TECHNICAL BULLETIN

SUBJECT:
MULTITECH MODEM PARAMETERS

TECHNICAL BULLETIN: 17-22

DATE: DECEMBER 21, 2017

M/N: MT5600SMI
B/O - 34

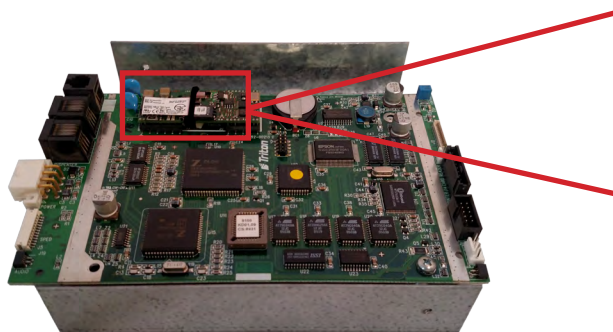
MultiTech changed the default error control and synchronous mode parameter from 1 to 3. Triton has discovered that this can cause a failure to communicate with Triton Connect when using a Systech modem. Any 81XX/91XX /96XX/97XX ATM equipped with a MultiTech MT56XXSMI modem series with B/O: 34 version should change the initialization string for Triton Connect to +ES=1 to avoid communication issues. Verify modem model, then follow steps below to configure.

1. Navigate to *Management Functions > Configure Terminal > More > Communication > Modem Configuration > Modem Setup String > Triton Connect Call String*.
2. Select **Change**. Terminal will not visually prompt user that it is ready for input.
3. Enter the value: **+ES=1**.
4. Press **Enter** on the keypad to complete configuration.
